U. S. NUCLEAR REGULATORY COMMISSION
REGION I

Report Nos. 50-272/94-11
50-311/94-11
50-354/94-09

Facilities: Salem Nuclear Generating Station
Hope Creek Nuclear Generating Station

Dates: March 27, 1994 - April 30, 1994

Figure 1

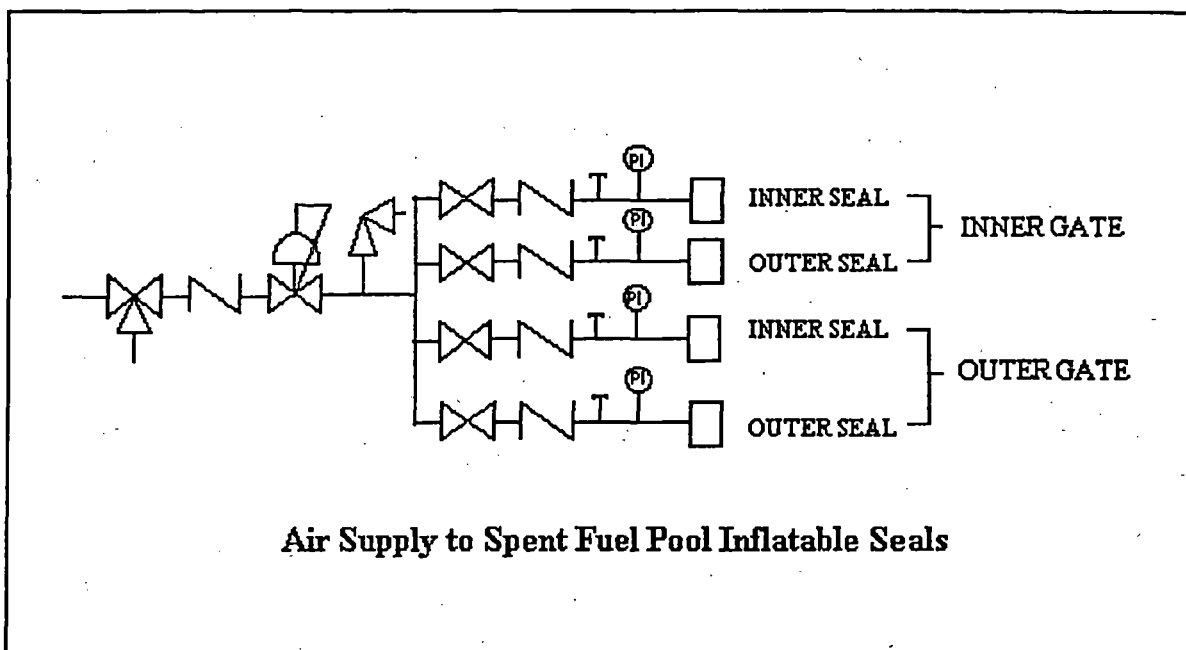
On April 13, 1994, a Hope Creek nuclear control operator (NCO) observed fuel pool skimmer surge tank level decreasing rapidly, indicating leakage from the SFP. The SFP low level alarm sounded, followed by a report that the SFP outer gate inflatable seals were leaking. The inner gate seals (2 seals per gate) had just been replaced and were still deflated. The licensee discovered that the air supply isolation valve to the inflatable seals was in the closed position and opened it, re-inflating the gate seals and stopping the leak. SFP level was restored to normal within 50 minutes of leak discovery. The water leaked from the SFP to the reactor cavity, with some spillover into the dryer-separator pool. No leakage into the drywell was discovered and no refuel floor radiation monitor alarms were received.

Licensee root cause analysis revealed equipment, procedure and personnel problems during the April 11-13 replacement of the SFP inner gate inflatable seals. The inflatable seals' air supply isolation valve was listed as normally closed in the Tagging Request Inquiry System (TRIS). This valve was recorded as open on April 5 after SFP gate installation and was subsequently closed sometime before inner gate seal replacement on April 13. The SFP gate inter-space drain valve, required to be open by procedure HC.OP-IO.ZZ-0001(Q), *Refueling to Cold Shutdown*, was improperly left closed after gate installation, which disabled the alarm for leakage into the inter-space region between the two SFP gates. The work order for gate seal replacement referenced the wrong procedure and excluded the correct procedure from the package. Mechanical maintenance practices for SFP gate seal replacement did not meet management expectations in that the job supervisor proceeded without an approved procedure. Maintenance personnel repositioned valves without a tagout. Lastly, the in-line check valves to the outer gate seals leaked, since those seals deflated during this event.

The inspector concluded that licensee root cause analysis and corrective actions were adequate to prevent recurrence. However, the inspector observed some weaknesses which were not addressed. The procedure that was expected to be used required tagging valves,

while the work order did not require a tagout. The procedure required pressurizing and depressurizing the SFP gate inflatable seals, but did not specify which seals or how to do it. Additionally, the licensee knew of the inner gate seal leak when installing the gates on April 4, but completed the installation and drained the reactor cavity without repairing it. The inspector also found that the licensee had never performed preventive or corrective maintenance on any of the valves or the pressure regulator in the air supply system (refer to figure 1., above). The existing design permits failure of a single component to permit loss of air to the seals. The inspector also determined that the loss of spent fuel pool inventory required failure of multiple barriers, including: hardware (check valve leakage), process controls (incorrect positioning of the three-way valve, failure to hang tags, inadequate control of isolation valve position), and people (lack of recognition that the newly replaced seal did not properly inflate, failure to check the three-way valve, failure to clarify and correct the work package reference to an incorrect procedure for seal replacement, performing work without a procedure, failure to recognize that the tag requirement had not been met).

Licensee corrective actions addressed the identified root causes and included other considerations as well. The TRIS for the air supply isolation valve was changed to reflect a normal position of locked open. Operators responsible for the failure to reopen the gate

inter-space drain valve were appropriately disciplined. The mechanical maintenance engineer discussed the importance of procedure compliance with all members of the mechanical maintenance shop, directed the creation of a new procedure dedicated to SFP gate seal replacement, and instituted a work package evaluation program to ensure procedure effectiveness. The operations department initiated a work order to replace the in-line check valves to each of the four inflatable seals. Additionally, the licensee wrote and answered a deficiency report to evaluate the effect of flooding the reactor well drywell cavity with the drywell head installed. This evaluation showed no negative impact on the drywell head by hydraulic forces or water damage/corrosion effects. Long term corrective actions included operator checks of SFP gate seal pressures, recurring tasks for periodic calibration of the gate seal pressure gages and in-line check valve replacement, and a design change request to improve gate seal air supply reliability.
